Licence Number	L4247/1991/13
Licence Holder	Talison Lithium Australia Pty Ltd
ACN	139 401 308
Registered business address	Level 4 37 St Georges Terrace PERTH WA 6000
File Number	2012/007164
Premises	Talison Lithium Mine Mining Tenements M01/3, M01/6, M01/7 General Purpose Tenements G01/1 and G01/02 GREENBUSHES WA 6254
Date of Amendment	30 August 2017

Amendment

On 15 December 2016, Talison Lithium Australia submitted an application to amend their Licence L4247/1991/13 to authorise the installation and operation of an additional crusher and chemical grade lithium plant, with a capacity of 2.4 million tonnes per year. The crusher and plant would be located to the south of the existing processing plant, on a former tailings storage facility. An additional product storage bund (also referred to as the concentrate stockpile) will also be constructed to the east of the existing plant. Refer to Figure 1 for the proposed location of the new plant.

Figure 5: Surface stormwater drainage plan - Chemical Grade Processing Plant

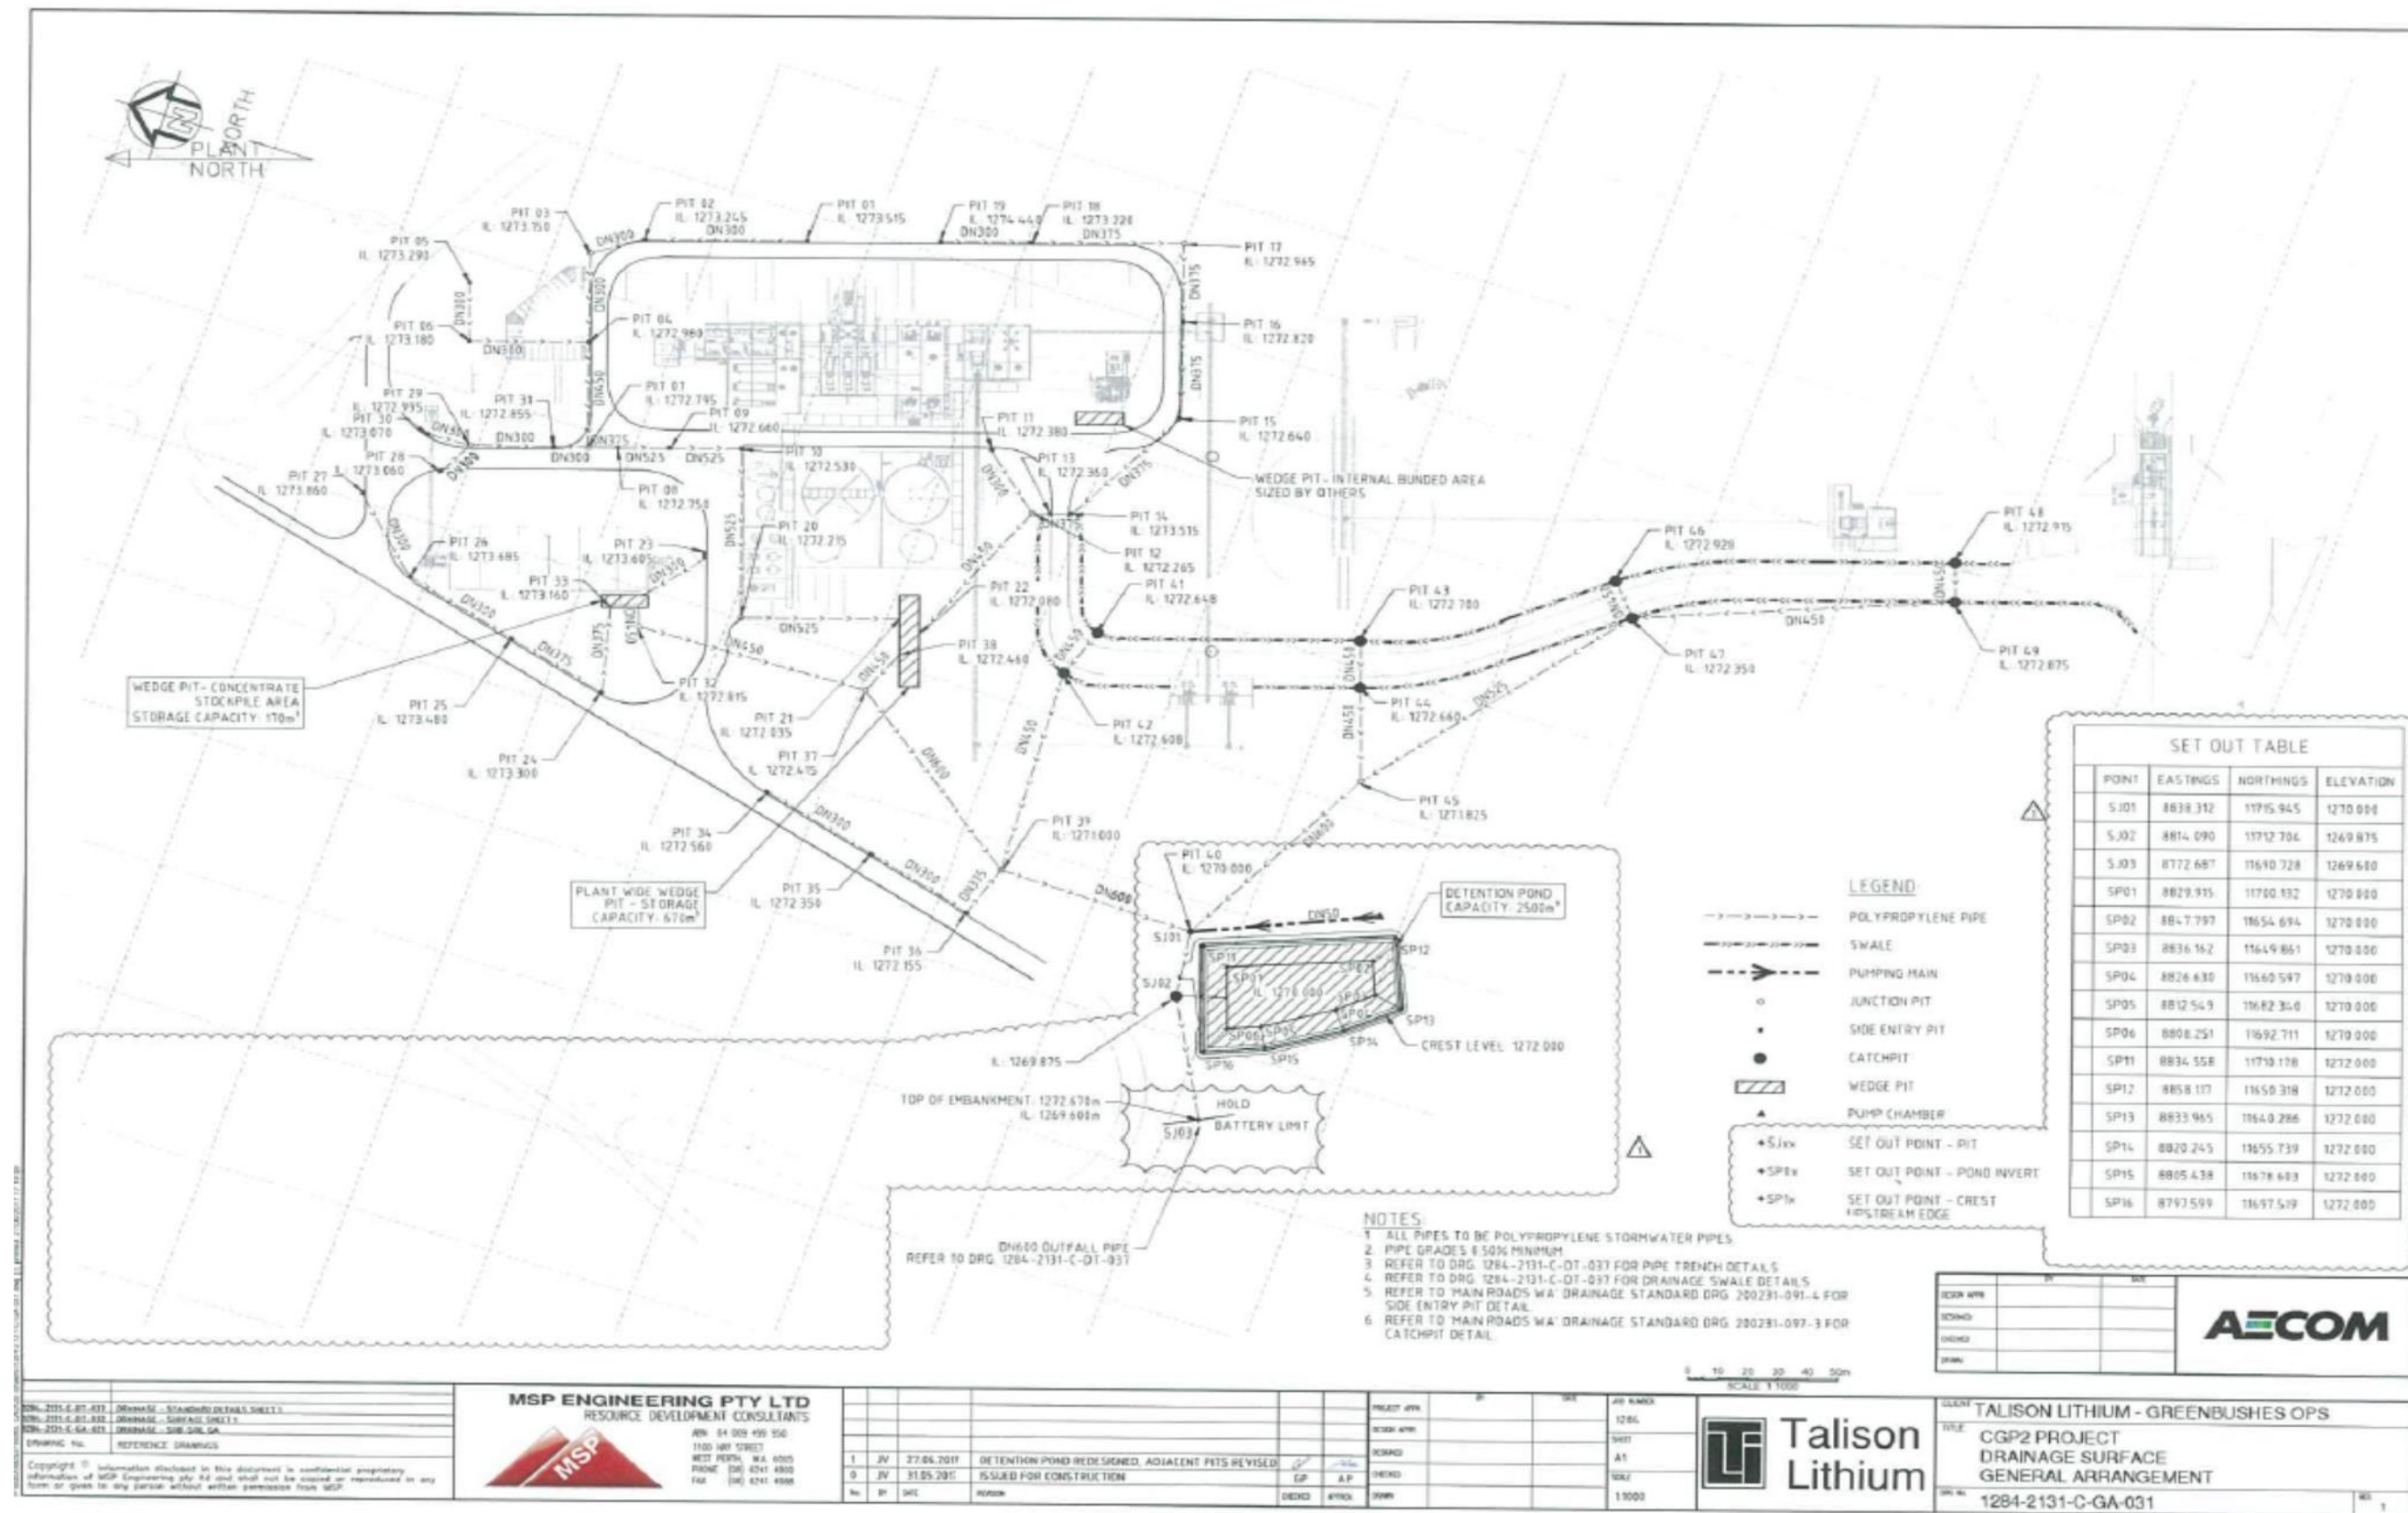
(b) capacity of the wedge pits and south west detention pond as shown in Figure 5 of Schedule 1.

10. Schedule 1 of the Licence is amended by the insertion of Figure 5 shown below:
